ADDENDUM NUMBER 02

DATE: 3/3/2023

PROJECT: SCM Carpet Replacement Project

PROJECT NUMBER: 22-1723

FINISH PLAN - H&C WING

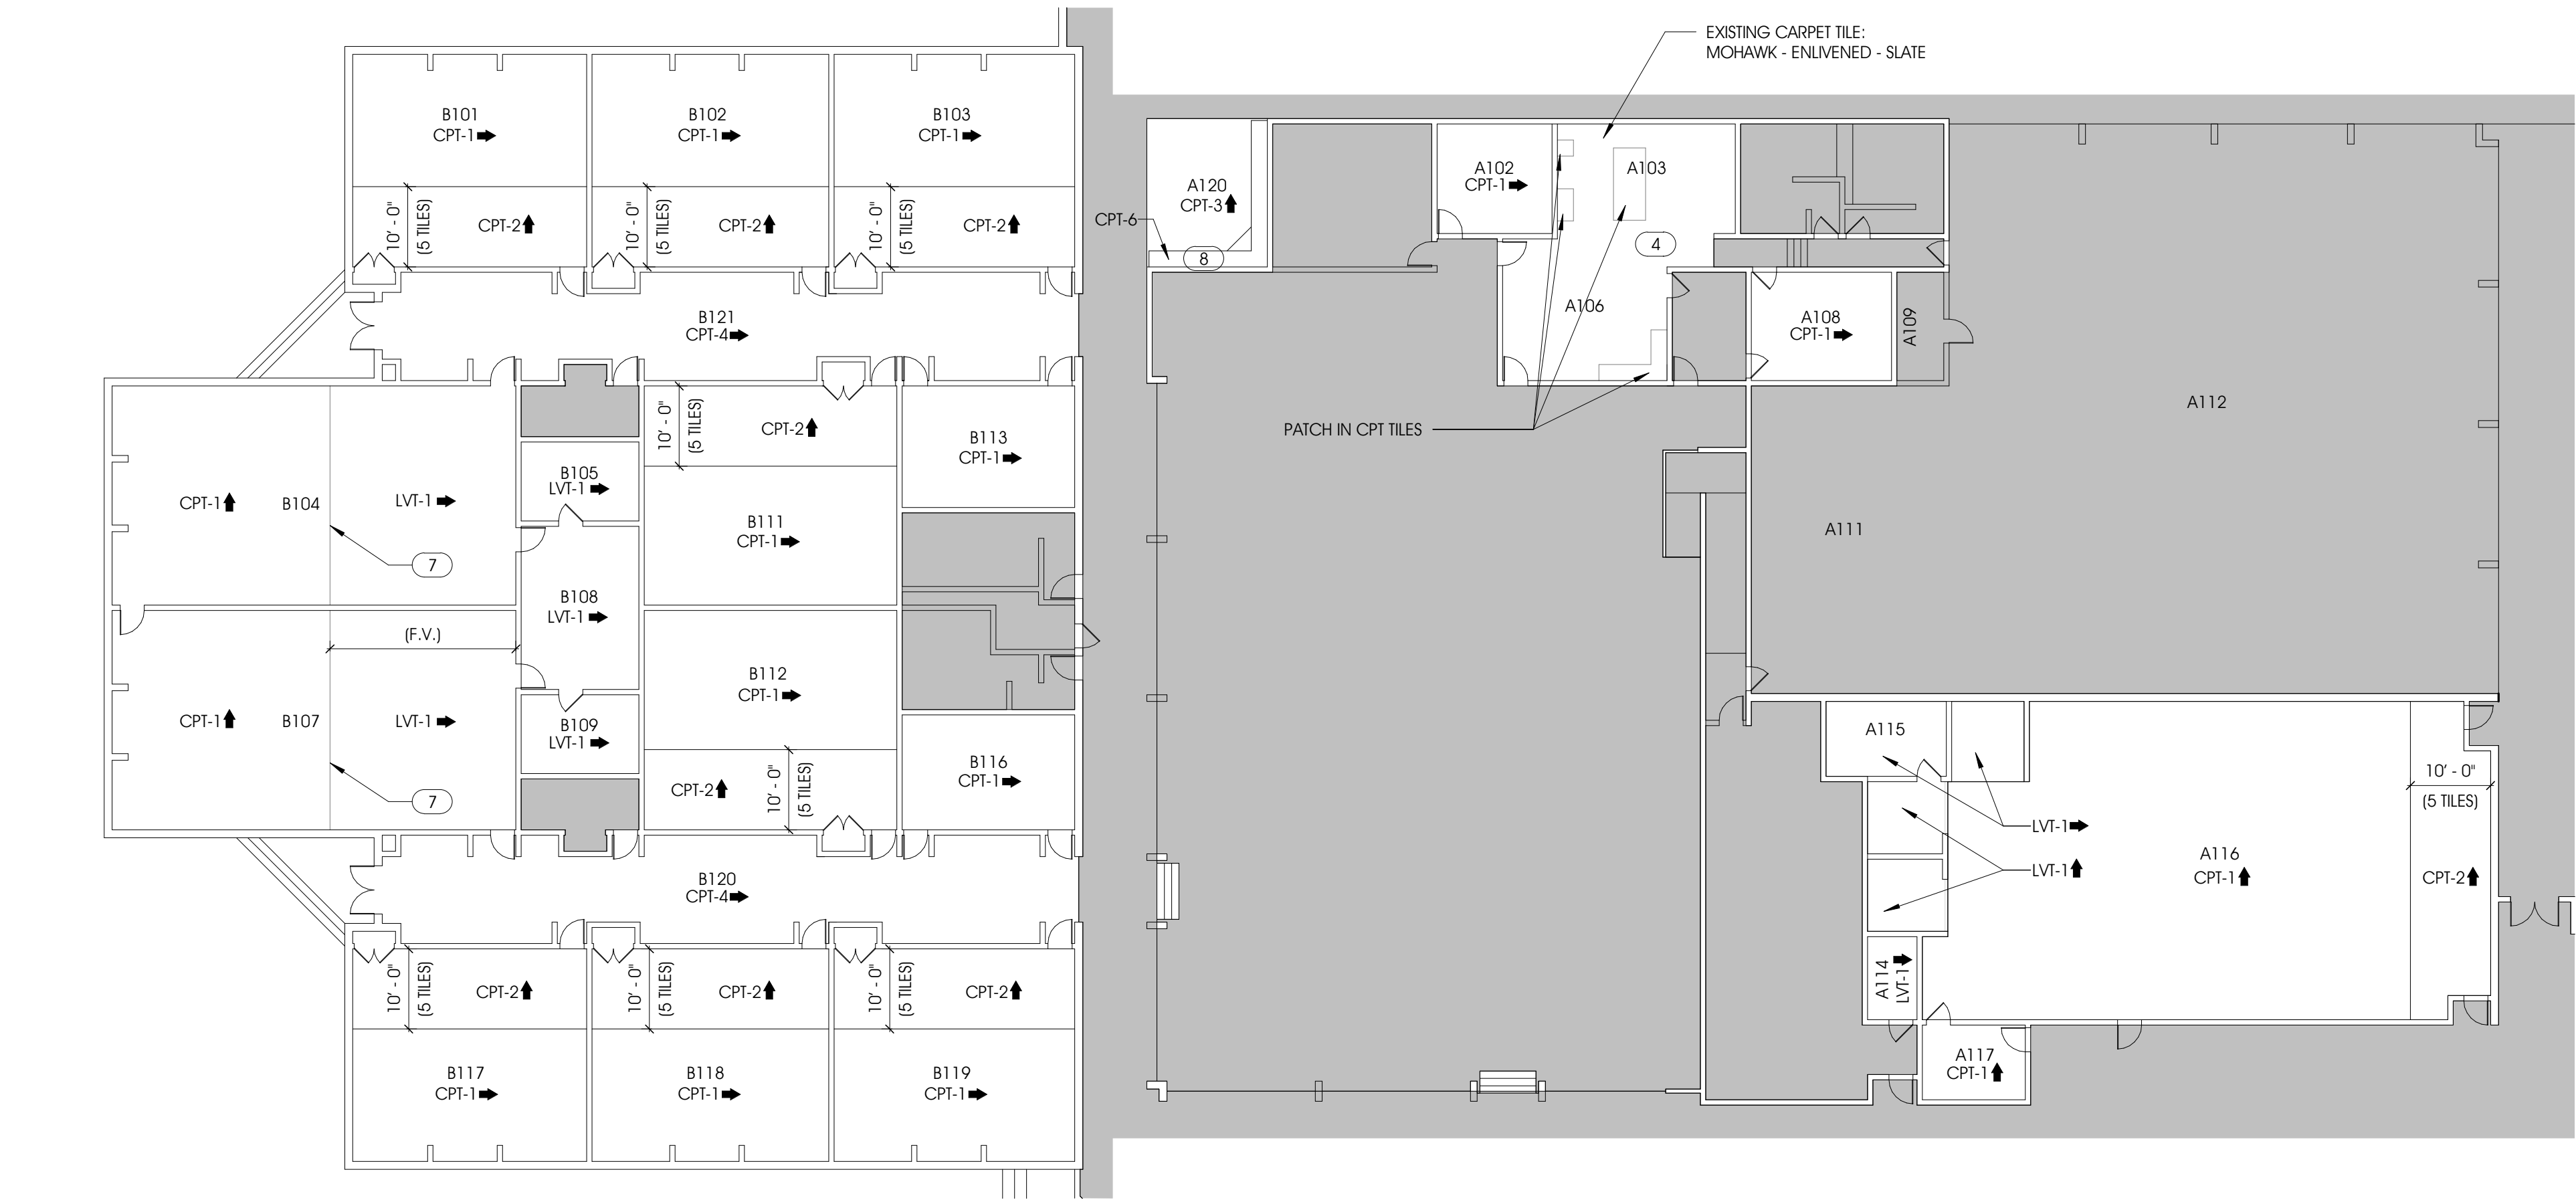
8. **REPLACE** keynote information for CPT-2 with Mohawk – Live and Learn - Side Stripe – CUSTOM: A12G1195 Mohawk#: 50W31-Q7919.
9. **REPLACE** keynote information for LVT-1 with Milliken – Lumenology – Light Stitch – Dim LLS13.
